MONUMENT GLAMPING SITE PLAN
16315 RICKENBACKER AVE.
MONUMENT, CO 80132

SITE PLAN

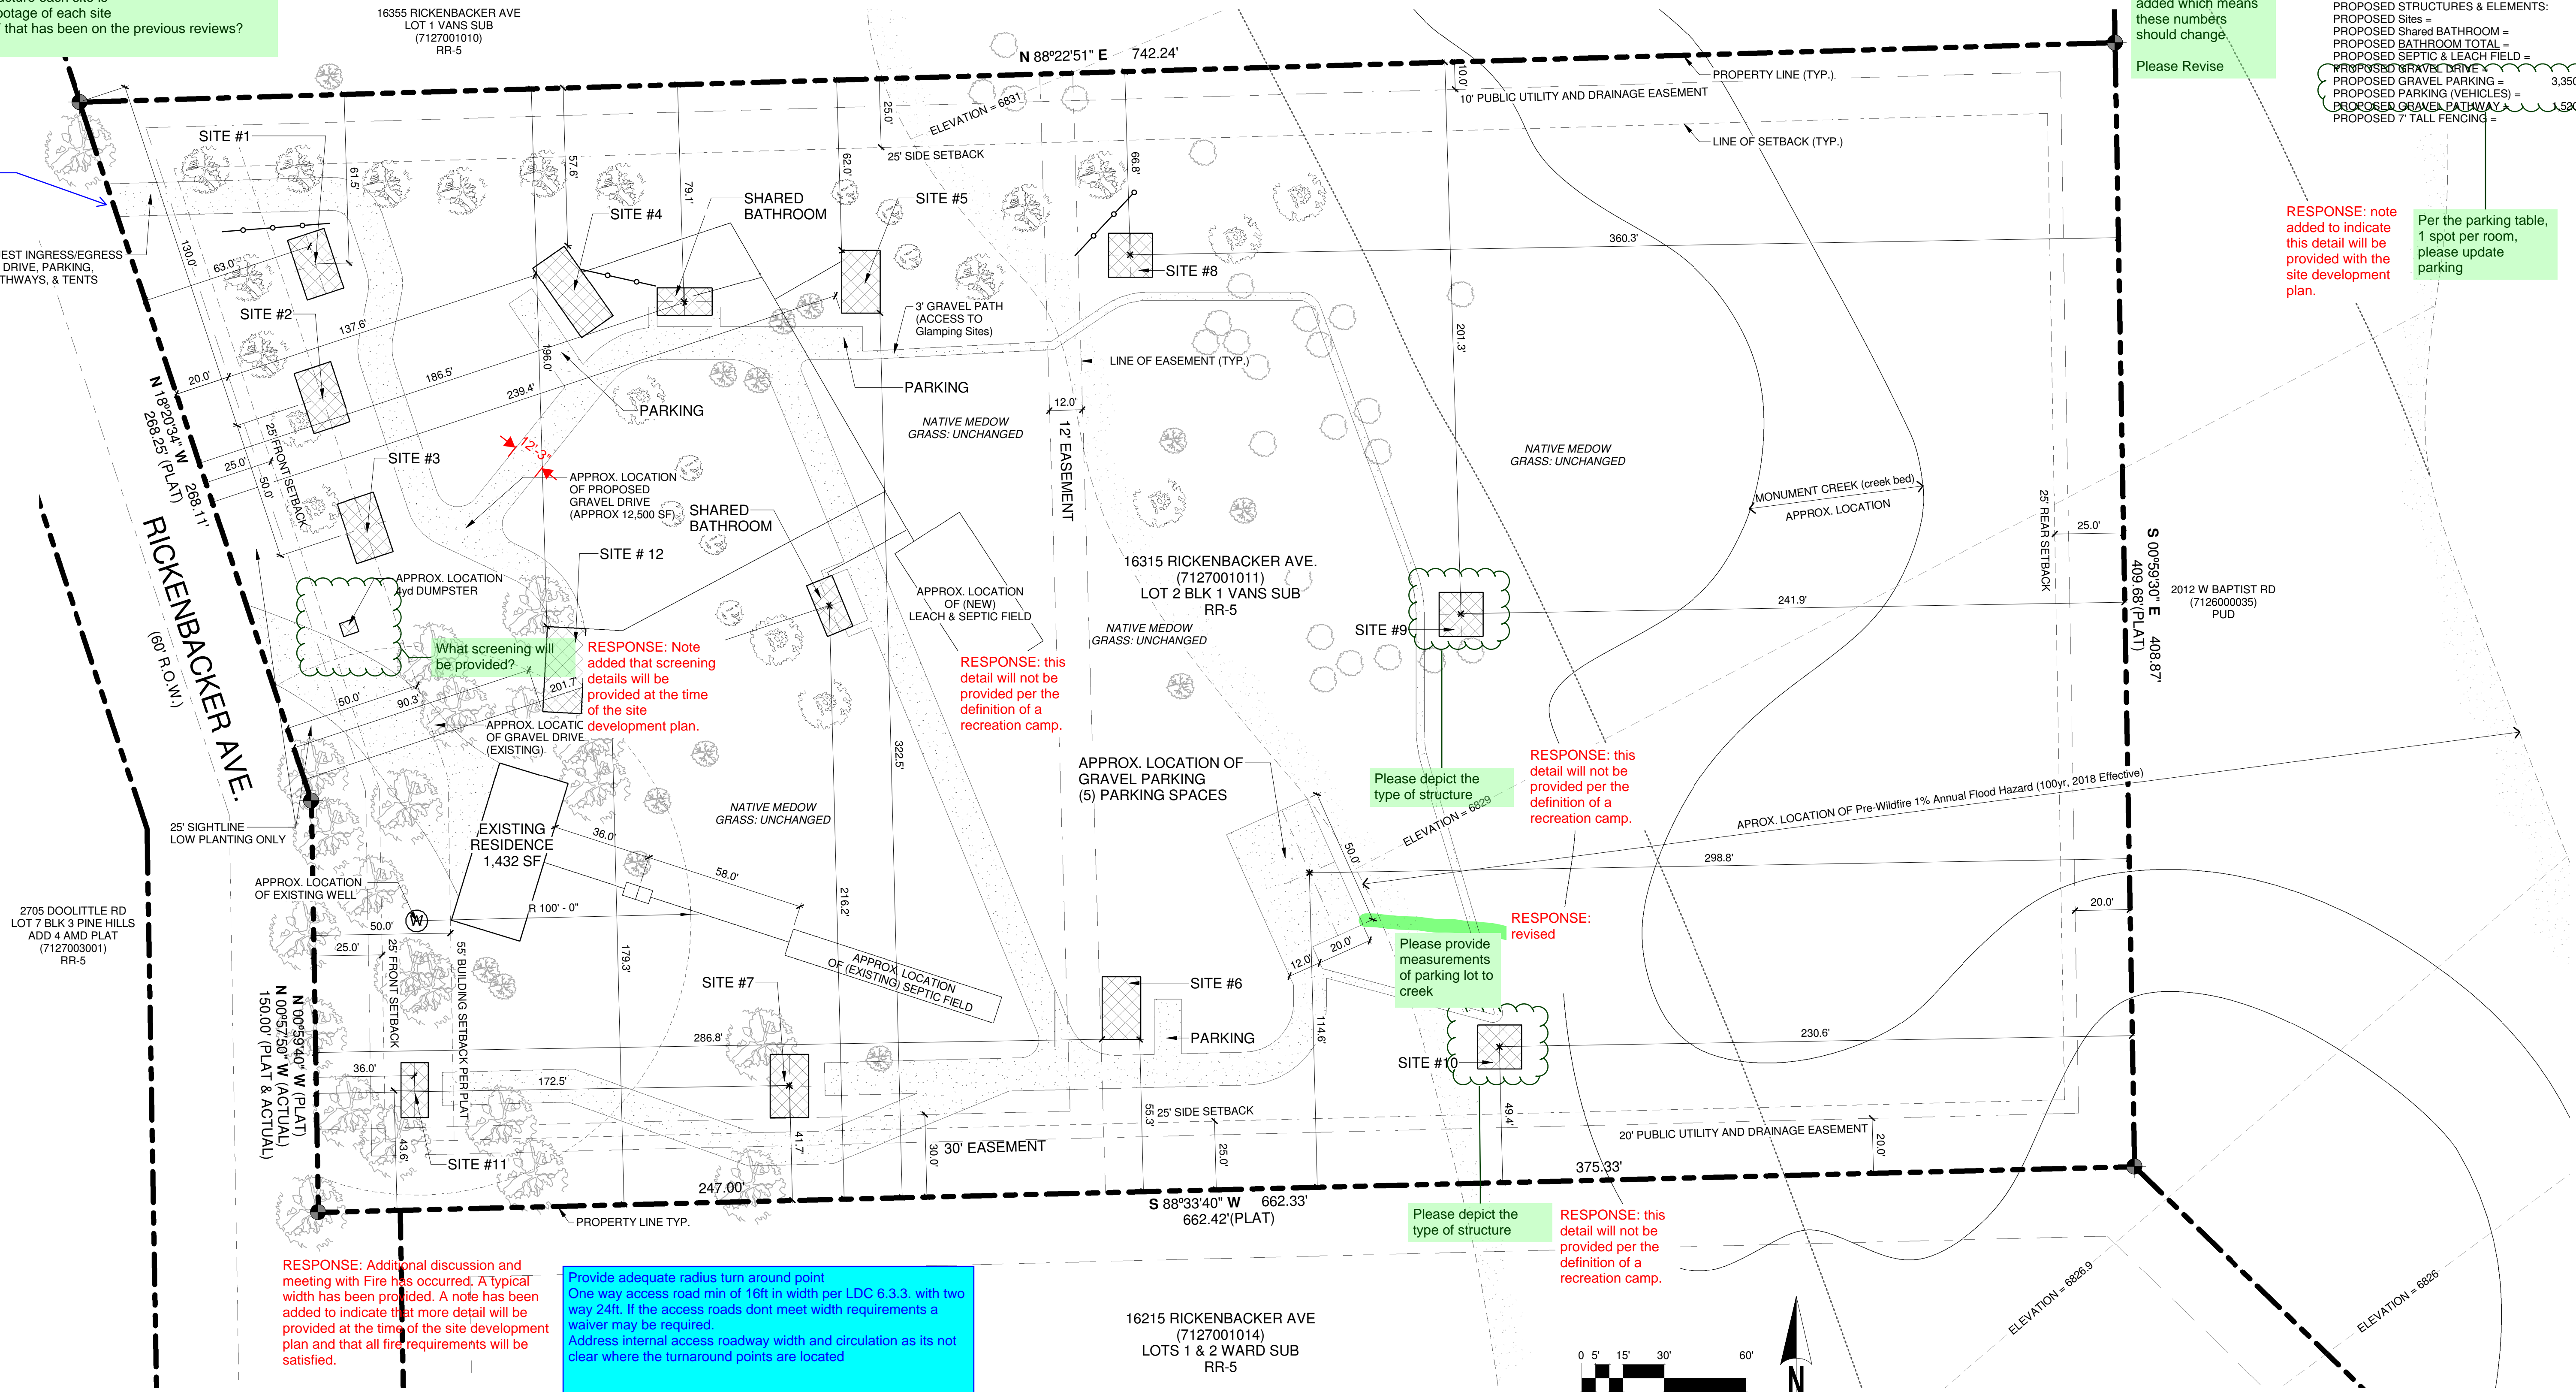
Please include:
 -what type of structure each site is
 -what is the sq footage of each site
 -where is the RV that has been on the previous reviews?

Please submit a secondary driveway access permit for the new driveway. Instructions will be provided in the EDARP review comment.

1432 + 480 + 3134 + 210 = 5,256
Please Revise

These numbers are the same as previous submittal and the proposal is asking for 4 more sites being added which means these numbers should change

Please Revise

Per the parking table, 1 spot per room, please update parking

Provide adequate radius turn around point
 One way access road min of 16ft in width per LDC 6.3.3, with two way 24ft. If the access roads dont meet width requirements a waiver may be required.
 Address internal access roadway width and circulation as its not clear where the turnaround points are located

Please depict the type of structure

Please provide measurements of parking lot to creek

Please depict the type of structure

RESPONSE: The type of structure will not be included, as the nature of a recreation camp is that the structures are temporary. A note has been added to reflect this.

A typical site dimension has been added along with a note identifying that the limits of the space will be further defined with the site development plan.

RESPONSE: the secondary driveway permit will be submitted at the time of the site developed plan application.

RESPONSE: revised per "typical"

RESPONSE: revised

RESPONSE: note added to indicate this detail will be provided with the site development plan.

RESPONSE: Additional discussion and meeting with Fire has occurred. A typical width has been provided. A note has been added to indicate that more detail will be provided at the time of the site development plan and that all fire requirements will be satisfied.

RESPONSE: this detail will not be provided per the definition of a recreation camp.

RESPONSE: this detail will not be provided per the definition of a recreation camp.

RESPONSE: revised

RESPONSE: this detail will not be provided per the definition of a recreation camp.
